Technical Information Bulletin**Required Parts Needed for Attaching New Fuel Sender to the CT660 On Highway Truck {7000}**

Media Number -TIBU7108-00

CT660 (S/N: TRK1-UP; TKL1-UP; TGT1-UP; TSW1-UP; TSY1-UP; TJS1-UP)

Illustration 1

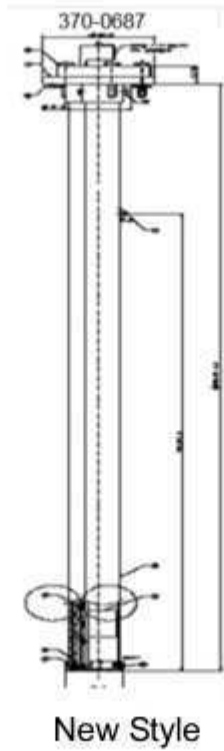
Early version of fuel sender had pigtail style connector. New style has a fixed style connector that requires three additional parts to connect to harness.

Old Style

Trucks that were built with a pigtail, and you receive a fuel sender without a pigtail you will need three additional parts to make the existing truck harness mate with the fuel sender.
